Laundry room — zone by zone

Current condition matched to the proposed enhancement, area by area

Seven zones identified from the walkthrough video and the site photographs. Each is paired with the concept render that shows its target condition, the specific interventions that apply to it, and where it sits in the four-tier budget.

Entry wall, 0:00–0:02 in the walkthrough

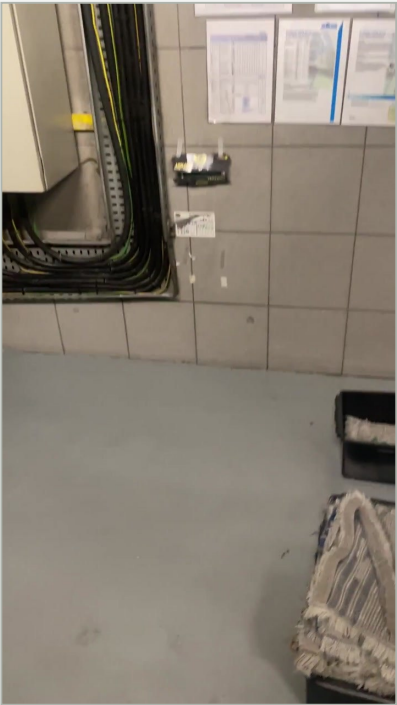
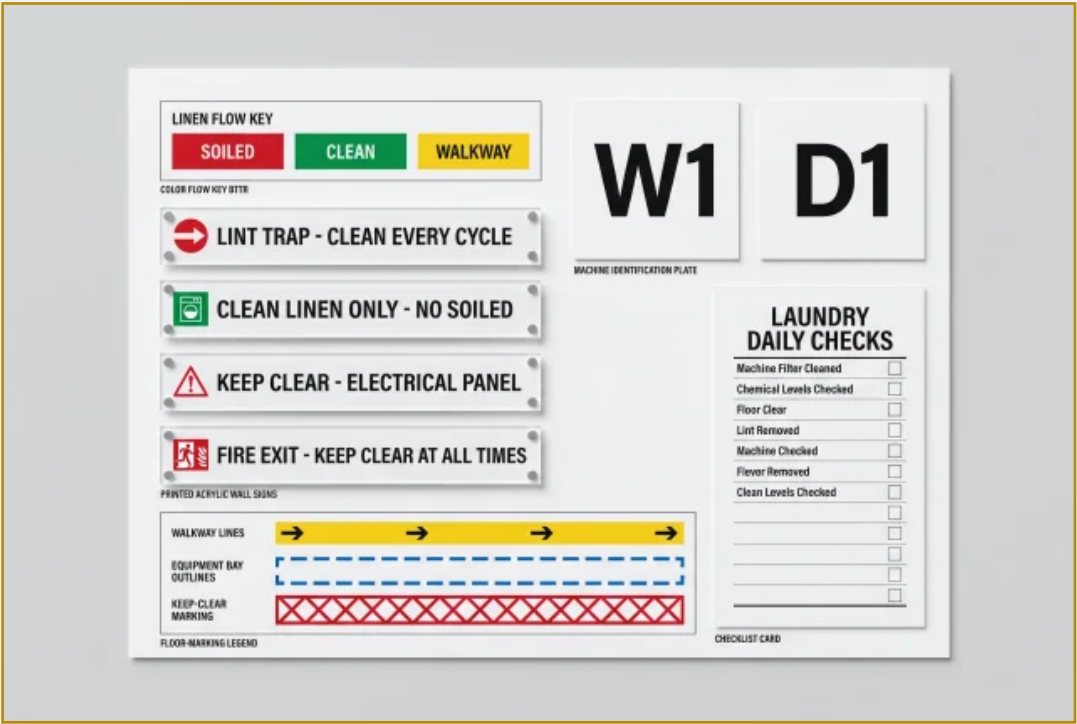
- A distribution board with heavy cabling entering, and roughly fifteen A4 sheets taped to the tile directly beside it.
- Open lint trays, a woven sack and a plastic storage box on the floor beneath the board.
- No keep-clear zone marked or maintained in front of the board.

- Strip the paper wall entirely. Combustible material does not belong against a live board.
- Clear the floor beneath and in front of it, then paint a keep-clear zone on the resin.
- Replace the paper with the printed kit: one KEEP CLEAR — ELECTRICAL PANEL sign at a fixed height.
- Documents move to the framed DAILY CHECKS board in the alcove (Zone 03).
